**Husky Exploration Drilling Project:  
Response to Information  
Requirements and Required  
Clarifications from Environmental  
Impact Statement Review**

Prepared for:  
Husky Energy

Prepared by:  
Stantec Consulting Ltd.  
141 Kelsey Drive  
St. John's, NL A1B 0L2  
Tel: (709) 576-1458  
Fax: (709) 576-2126

**ED-HSE-RP-0037**

**Figure 1 The Overlap Between EL 1151 and the Proposed Spotted Wolffish Habitat**

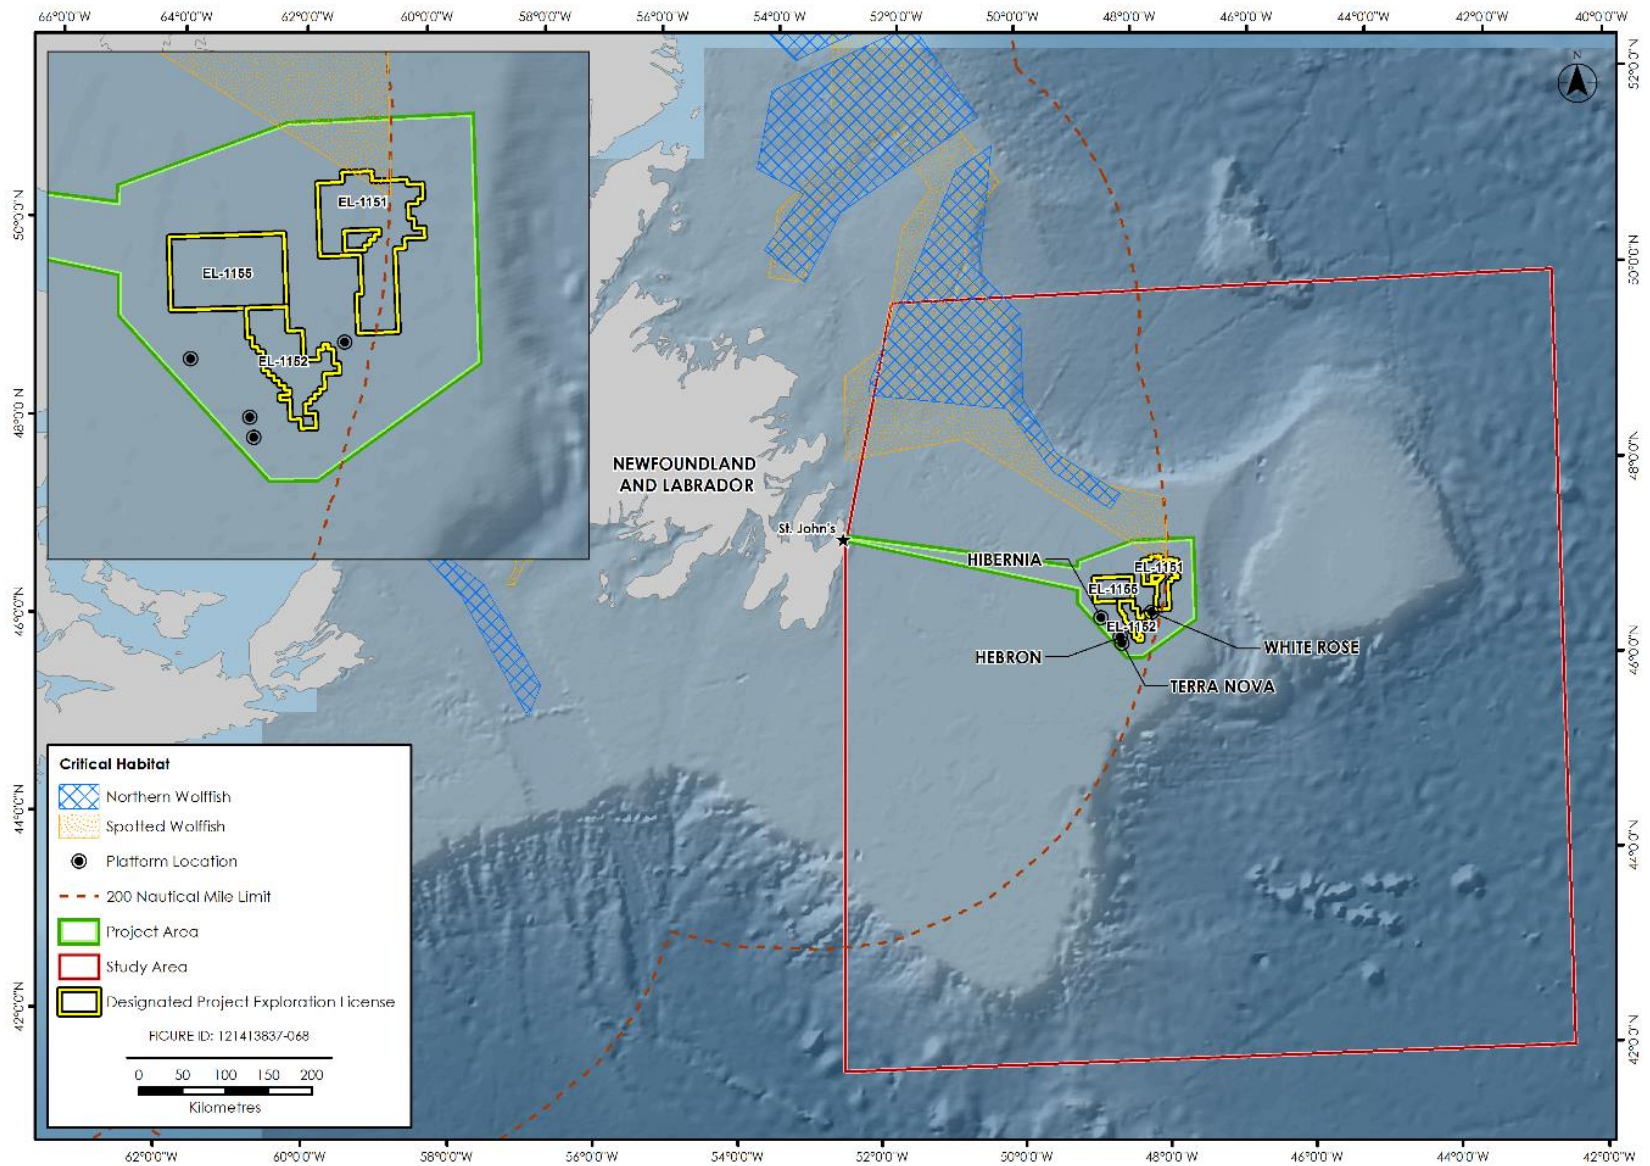
Figure 4-27 of the EIS illustrates the location of proposed critical habitat for Northern and Spotted Wolffish in relation to the location of the study area and ELs. The resolution of this figure illustrates an area of overlap between a portion of the proposed Spotted Wolffish critical habitat and EL 1151, however, this overlap is not discussed in the text of the EIS.

Exploration Licence (EL) 1151 overlaps with 50.5 km<sup>2</sup> of the proposed critical spotted wolffish habitat (Figure 1), which is approximately 0.05% of the proposed critical habitat area. This area also represents approximately 3.6% of EL 1151. Based upon Fisheries and Oceans Canada's (DFO) fall research trawl surveys, spotted wolffish are far more abundant on the continental shelf northeast of Newfoundland and on the Labrador Shelf than in the waters in and around the Project Area (Committee on the Status of Endangered Wildlife in Canada 2012; DFO 2018).

**Figure 1 Northwest Atlantic Fisheries Organization Divisions 3KLMNO Harvest, All Species, 2011 to 2016**

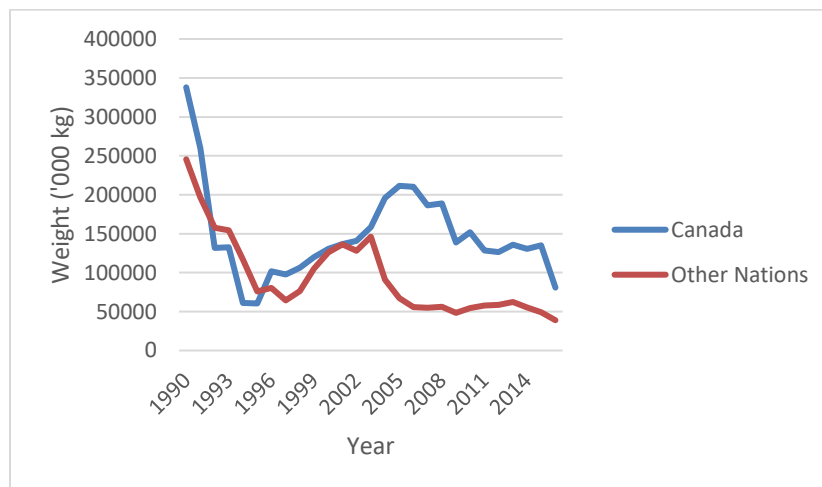
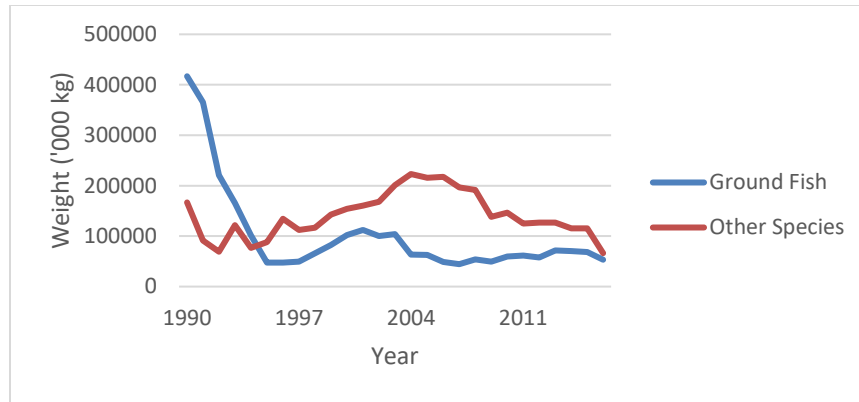
Confirm if the data presented in Figure 4-35, Figure 4-36 and in Table 4.46 includes harvest from NAFO Division 3K. If catch data from NAFO Division 3K has not been included, revise the related figures and tables, to present information on the harvest from all NAFO Divisions which overlap with the study area.

The source of data for Figures 4-35 and 4-36 is the NAFO STATLANT 21A database. Data from 2011-2016 were erroneously not included in the figures in the original EIS. Figure 1 (revised EIS Figure 4-35) and Figure 2 (revised EIS Figure 4-36) use data from all NAFO units that intersect the Study Area (3KLMNO). Figure 1 was modified slightly to show fish harvest both from Canada and other nations in order to be more consistent with the updated Section 4.3.1.1 as presented in the response to IR-69.

Figure 1 Sea Turtle Sightings in the Study Area (2004 to 2014) [revised]

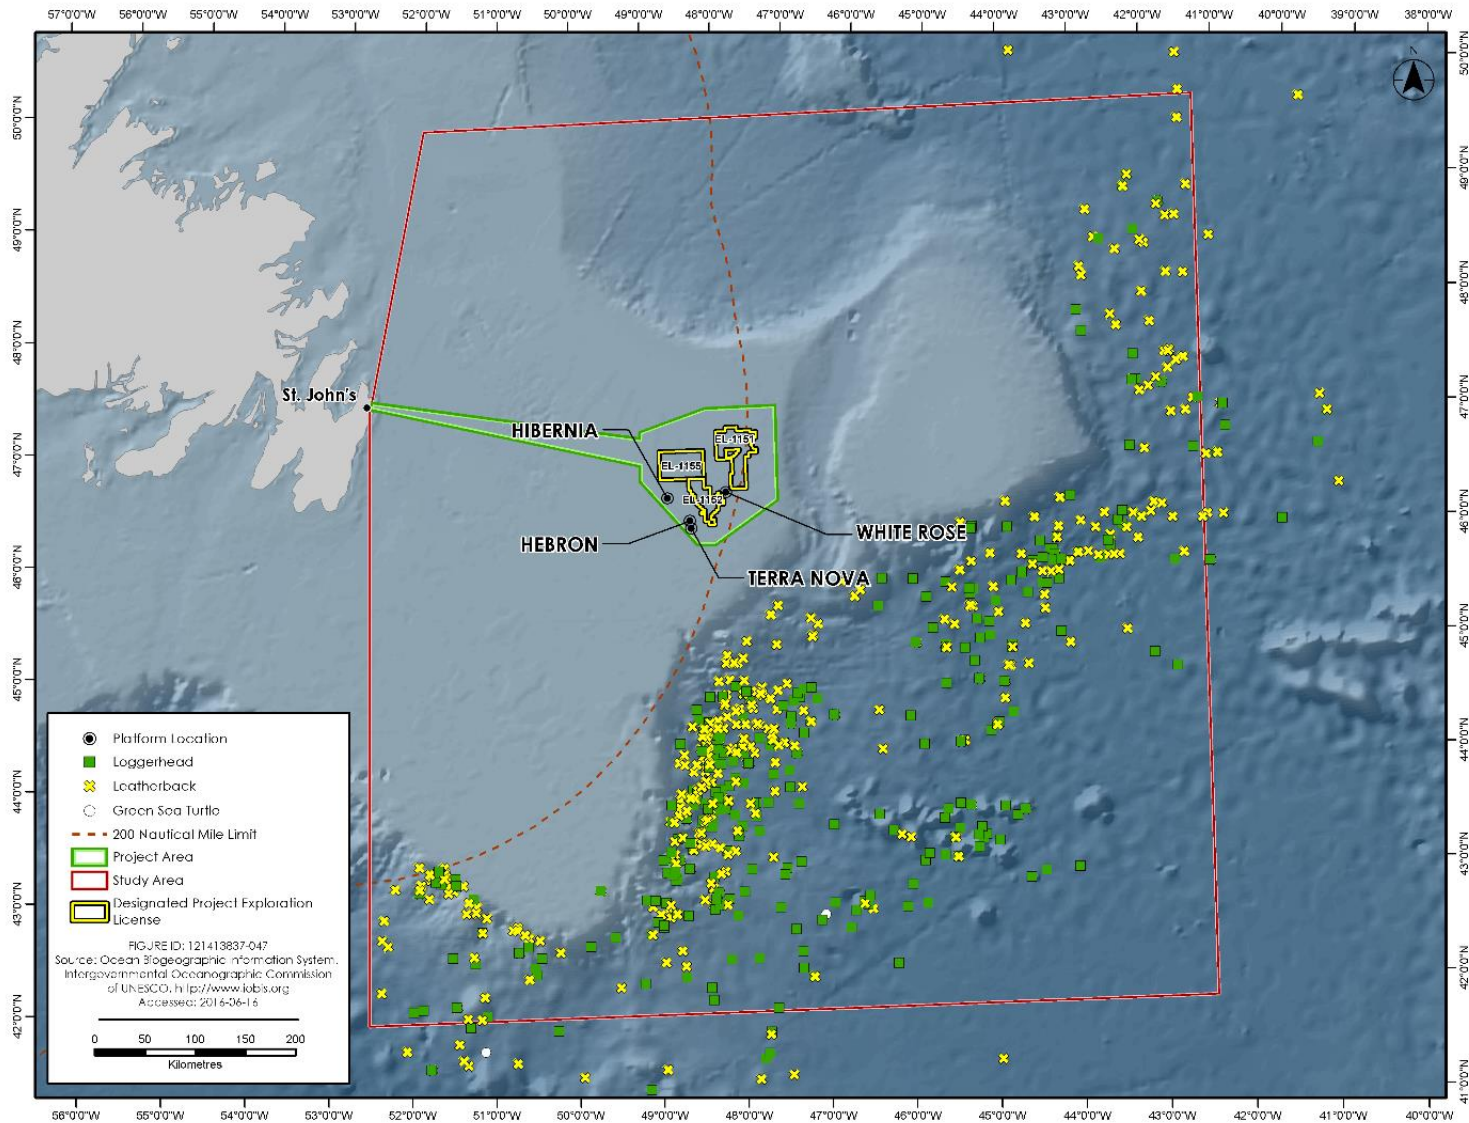
Figure 4-31 of the EIS shows sea turtle sightings in the study area; however, does not present data on a per species basis and therefore does not show species-specific range and occurrence.

Provide information to support Figure 4-31 to allow for species-specific sea turtle analysis.

A revised Figure 4-31 of the EIS identifying sea turtle sightings by species is provided as Figure 1.

Figure 1 Oil Spill Model Locations

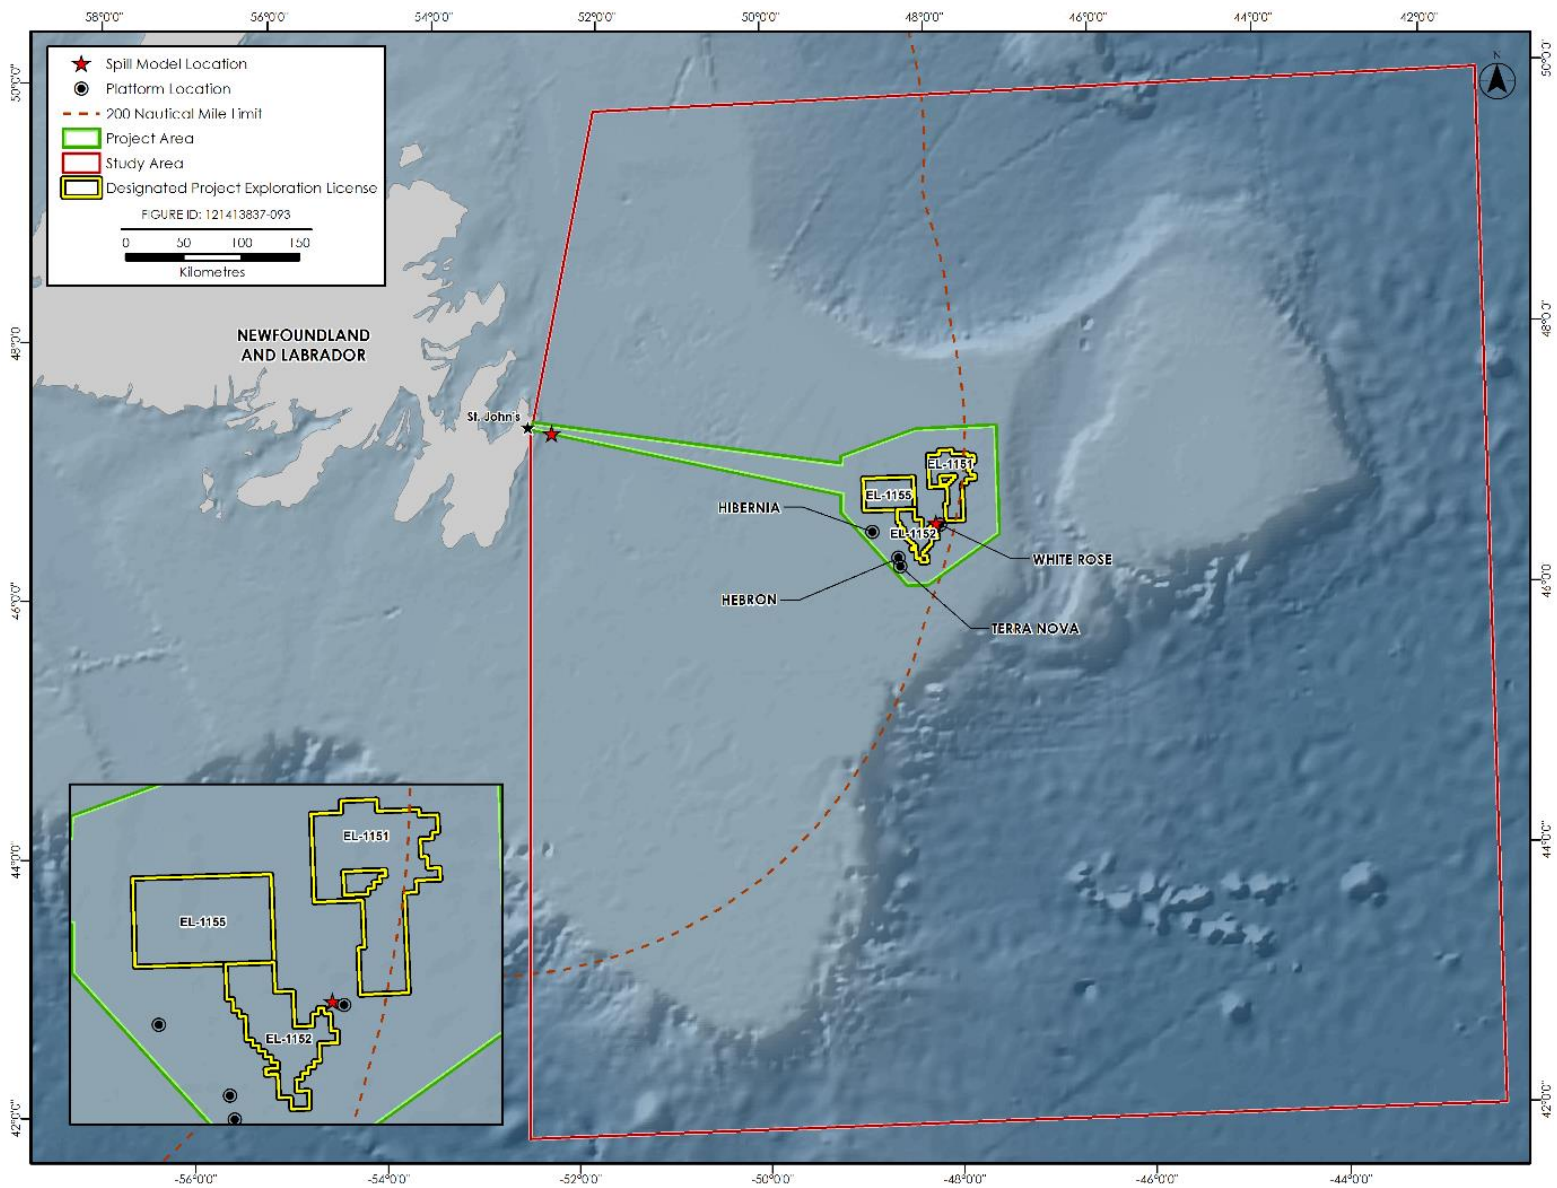
Figure 7-16 presents spill volumes of 16, 16, 100 and 300 cubic metres.

- Table 7.18: 0.16 volume was incorrect, it should be 16 m<sup>3</sup>
- Section 7.2.1.5: volumes are correct, but for consistency should be 1.6, 16, 100, and 350 m<sup>3</sup>
- Figure 7-16: the first volume is incorrect, it should be 1.6 m<sup>3</sup>

The origin of the spill modeling in the Project Area (and in relation to the Project ELs) is provided as Figure 1.

**Figure 1 Seismic Activity within the Study Area, 1988 to 2018**

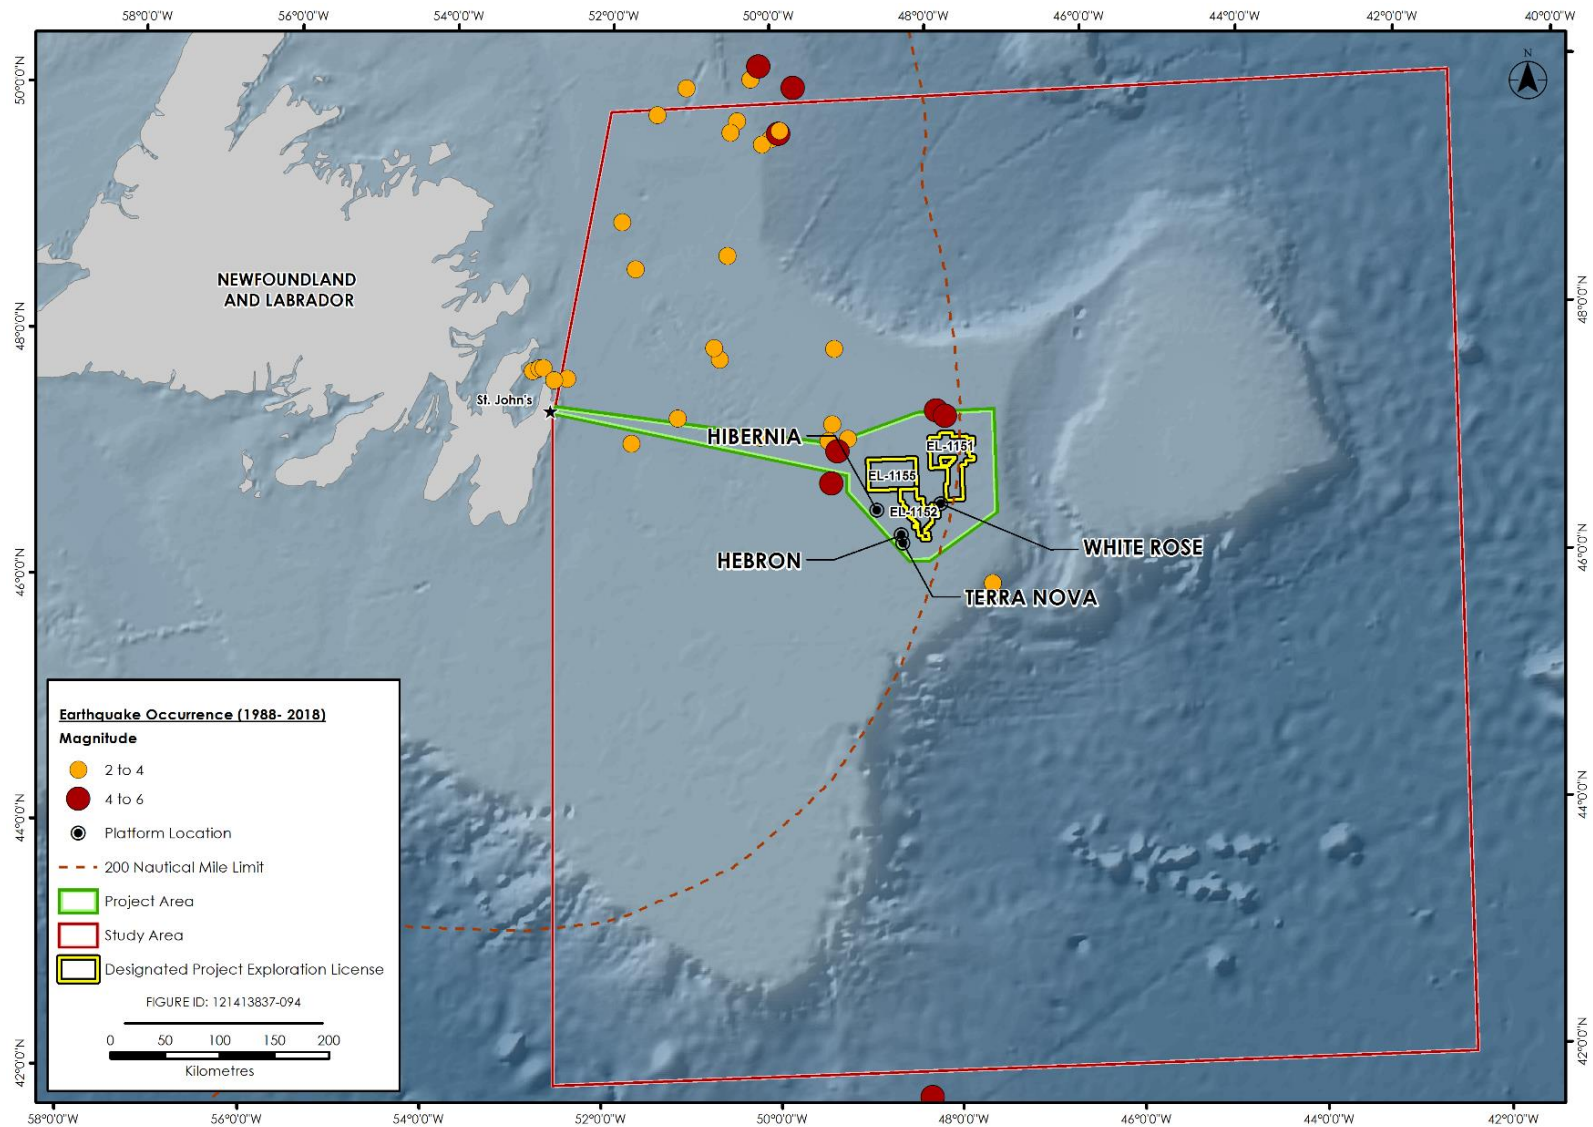
Table 8.1 and Figure 8.1 in Section 8.2.2.3 in the EIS provide a description of earthquakes within 500 kilometres of the White Rose field from 1988 to 2010. This section also provides information related to the earthquake that was recorded on September 2, 2018, however the proximity of this event to the Project is not clear.

Confirm whether the earthquake from September 2, 2018, was within 500 km of the White Rose Field. Update Table 8.1 and Figure 8.1 with earthquake data from 2010 to present, as applicable.

The earthquake on September 3, 2018 (292 km NE of Bonavista), is just outside the Study Area, approximately 430 km from White Rose. The updated earthquake locations are listed in Table 1 and illustrated in Figure 1.
